Access Compliance Report

Public Rights-of-Way

(Curb Ramps)

Intersection ID: 6463	Main Street: ROSY_MOUND_LN	Cross Street: SLATER_SPRINGS_DR	Location: NW
ADA ID: 9122501EC92A	Ramp Type: Perp	Initial Pass/Fail: Fail	Overall Compliance: No
Severity Score: 12.5			
Codes/Mitigation Info/Possible Solution		Field Measurements/Component Compliance

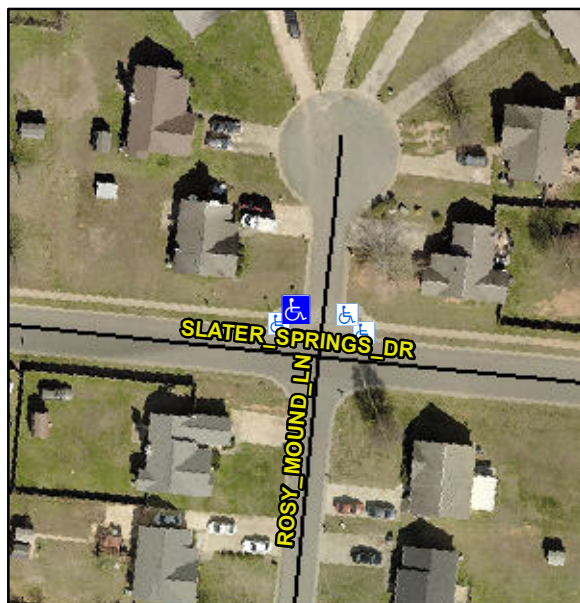
Not Found, R304.2.2

Compliance	Description	Data	Compliance	Description	Data
N/A	Ramp Length (in)	90.0	No	Ramp Slope (%)	9.0
Yes	Ramp Width (in)	48.0	Yes	Ramp XSlope (%)	0.9
N/A	Flare Type LT	N/A	N/A	Flare Type RT	N/A
N/A	Flare Slope LT (%)	N/A	N/A	Flare Slope RT (%)	N/A
N/A	Flare Traversable LT?	N/A	N/A	Flare Traversable RT?	N/A
N/A	Landing Length (in)	N/A	N/A	DWS Provided?	N/A
N/A	Landing Width (in)	N/A	N/A	DWS Contrast?	N/A
N/A	Landing Slope (%)	N/A	N/A	DWS Length (in)	N/A
N/A	Landing X Slope (%)	N/A	N/A	DWS Full Width?	N/A
N/A	Landing Curb? (Y/N)	N/A	N/A	DWS Offset (in)	N/A
N/A	Shared Landing?	N/A			
N/A	Gutter Ponding?	N/A	N/A	Gutter Slope (%)	N/A
N/A	Gutter Lip Ht (in)	N/A	N/A	Gutter X Slope (%)	N/A
N/A	Painted X Walk1?	No	N/A	Painted X Walk2?	N/A
	X Walk 1 Direction	To NE		X Walk 2 Direction	N/A
N/A	X Walk 1 Width (in)	N/A	N/A	X Walk 2 Width (in)	N/A
	X Walk 1 Slope (%)	0.1		X Walk 2 Slope (%)	N/A
	X Walk 1 X Slope (%)	2.1		X Walk 2 X Slope (%)	N/A

Remove & Replace Entire Ramp.
